LR-N05-0213  
LCR H04-01

**RESPONSE TO REQUEST FOR ADDITIONAL INFORMATION  
REQUEST FOR CHANGE TO TECHNICAL SPECIFICATIONS  
ARTS/MELLLA IMPLEMENTATION  
HOPE CREEK GENERATING STATION  
FACILITY OPERATING LICENSE NPF-57  
DOCKET NO. 50-354**

**HOPE CREEK GENERATING STATION  
FACILITY OPERATING LICENSE NPF-57  
DOCKET NO. 50-354  
RESPONSE TO REQUEST FOR ADDITIONAL INFORMATION  
ARTS/MELLLA IMPLEMENTATION**

Figure 1c-1

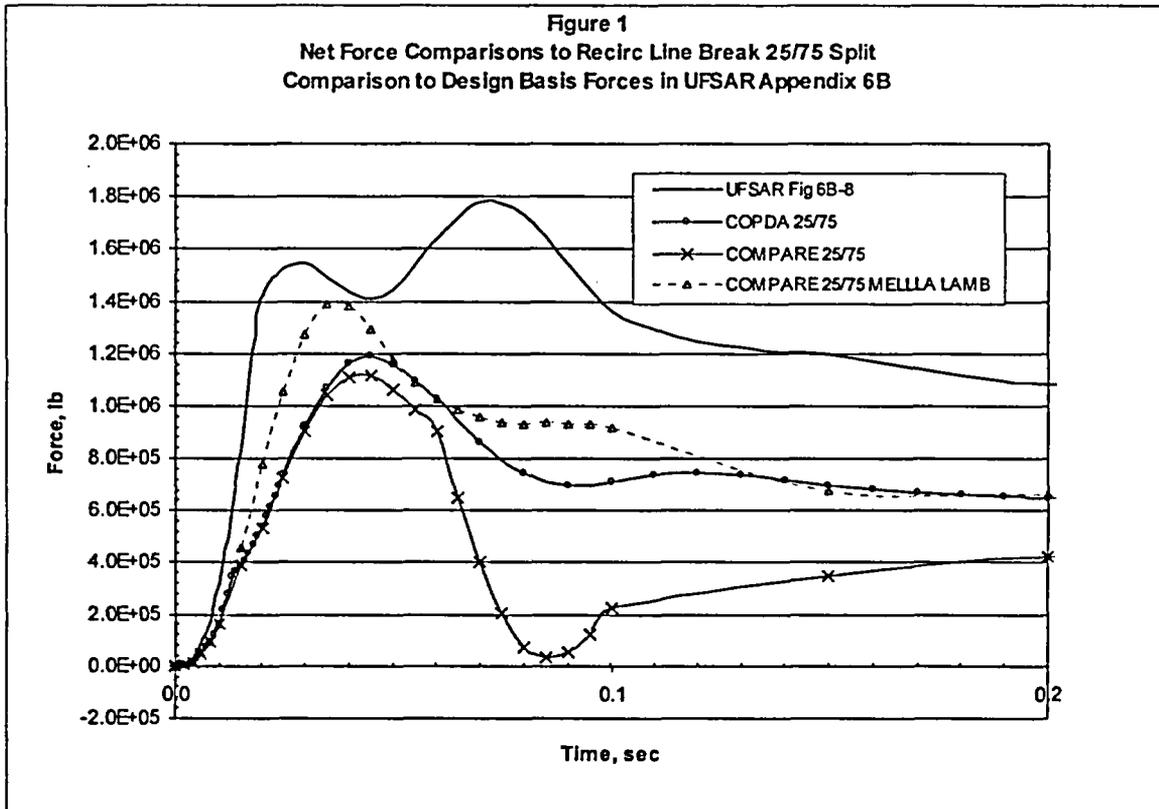
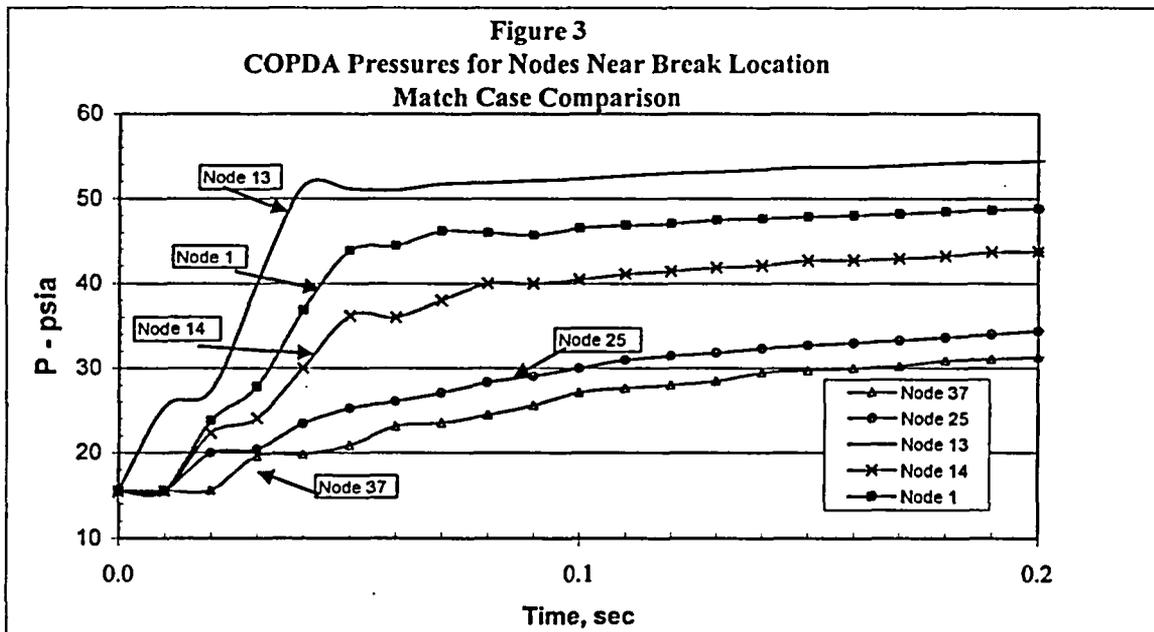
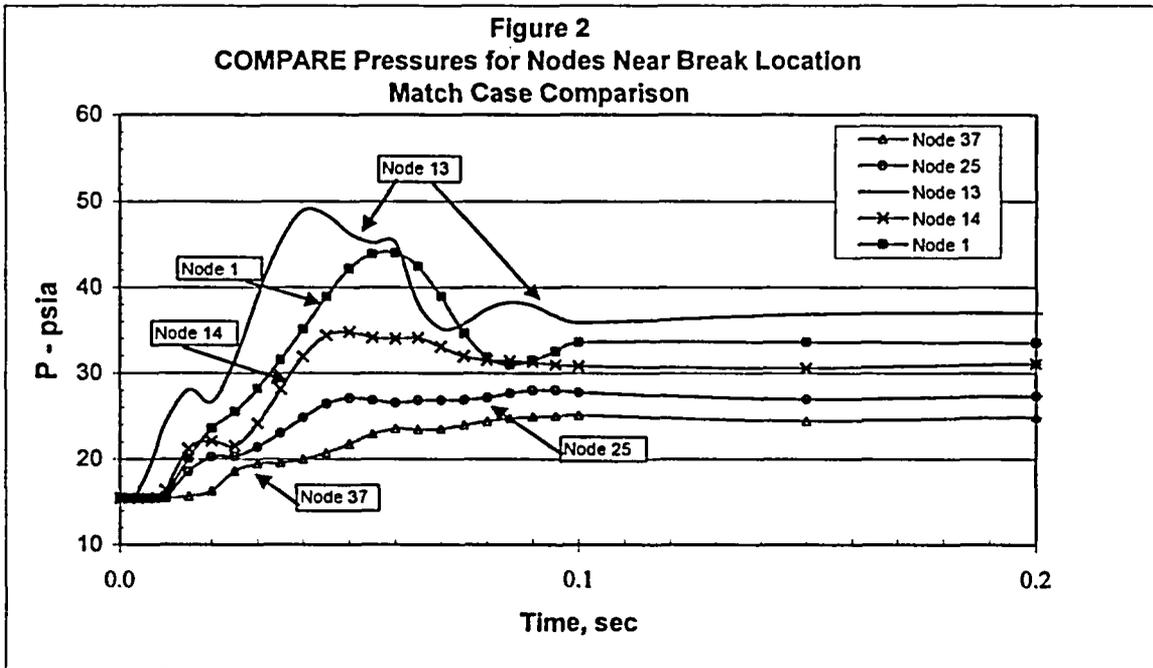
- c) Provide a discussion of the differences in the calculation of the subcompartment loads previously used for the reactor asymmetric loads evaluation (the COPDA code) to the proposed revised method using the COMPARE code. Include, for example, the treatment of heat structures, the treatment of the water-steam-air mixture for mass and heat transfer, and the treatment of the mass and energy as they enter the break control volume for mass and energy partitioning between the fluid and vapor states. Provide comparison graphs of the limiting control volume and differential pressures, over the time period of interest, for both methods.

COMPARE and COPDA pressure and net force comparisons were made for the 25% - 75% flow split case. COMPARE calculated pressure time histories that resulted in a total vessel force within approximately 7 percent of the maximum force predicted using COPDA's pressure time histories. In general, the COPDA analysis typically resulted in higher nodal pressures and differential pressures in the vicinity of the blowdown nodes. In the COMPARE analyses, the break mass and energy was more rapidly distributed resulting in higher nodal pressures away from the blowdown site for the time period from the break opening through the time of maximum resultant force. However, the resultant forces using the pressure results predicted by the COPDA and COMPARE codes were similar through the time of maximum resultant force. These forces were calculated in the same manner as described in Appendix 6B of the UFSAR.

Figure 1c-1 shows resultant force time histories similar to UFSAR Figure 6B-8. These comparisons show the HCGS design basis (50% - 50% flow split) and the COPDA and COMPARE match cases with 25% - 75% flow splits. Also, shown for comparison is the reactor vessel resultant force for MELLLA LAMB M/E with a 25%-75% split.

Figure 1d-1

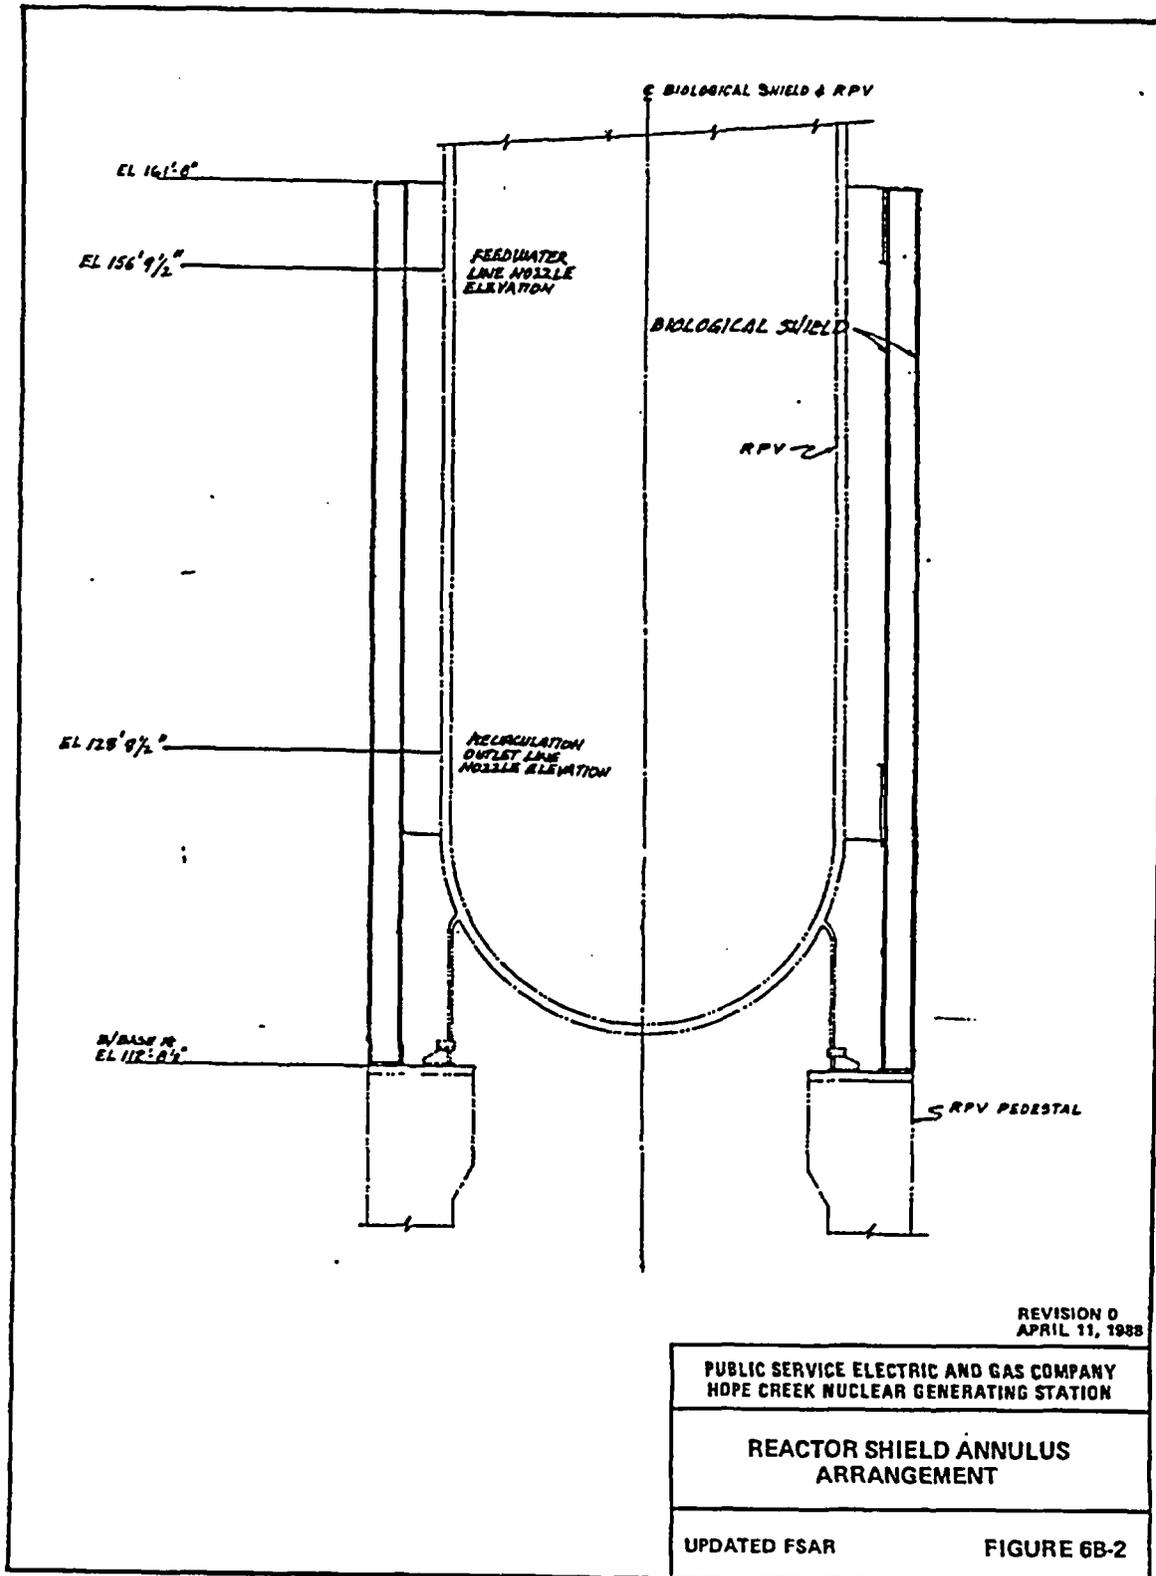
- d) Provide a design description of annulus region and the existing 25/75 flow diverter which limits the break flow into the annulus to 25% of the nominal value. Where is the postulated break located (i.e., on the recirculation or the feedwater line) and where does the remaining flow go? Is this flow reduction the major contributor to meeting the design requirements? Was the diverter considered in the original code calculations? If not, was a COPDA calculation [done] with the diverter, and what were the results?

The general layout of the annulus region between the reactor pressure vessel and the biological shield wall is shown on Updated Final Safety Analysis (UFSAR) Figure 6B-2, provided here as Figure 1d-1. The flow diverters installed in the shield wall penetrations for the recirculation outlet lines are shown in UFSAR Figure 6B-1, provided here as Figure 1d-2.
